From: Jacob Halverson <jacob.halverson@mercerisland.gov>
Sent: Friday, December 8, 2023 2:30 PM
To: Dave @ Chesmorebuck
Subject: Comment question - #2306-124 5425 W. Mercer Way

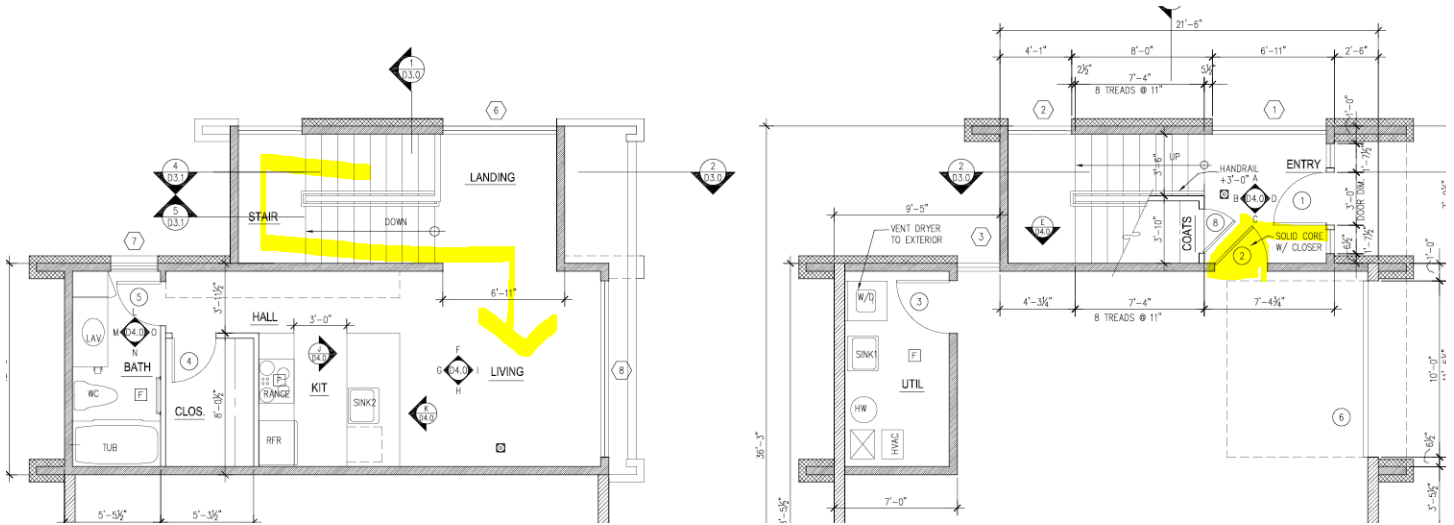
Following up with your question regarding the third party reviewer comment. After our conversation I believe we are discussing the area located here in the project.

1. Openings from a private garage directly into a room used for sleeping purposes shall not be permitted per IRC R302.5.1. Please provide an additional door to the sleeping area at the DADU. A condition without this additional door would need to be approved by the building official.

I understand your interpretation as the professional is that the door does not lead directly into the sleeping room. I also see that the layout of this ADU is unique and its relation to the garage would be a cause for concern.

I agree with your interpretation that this door does not lead directly into the living area. With the key word being directly. I understood that you are revising the upper floor to provide an additional means of egress out of the "living" room in response to another comment via an emergency escape and rescue opening requirement. If this is the case it also eases any concern I have for this condition.
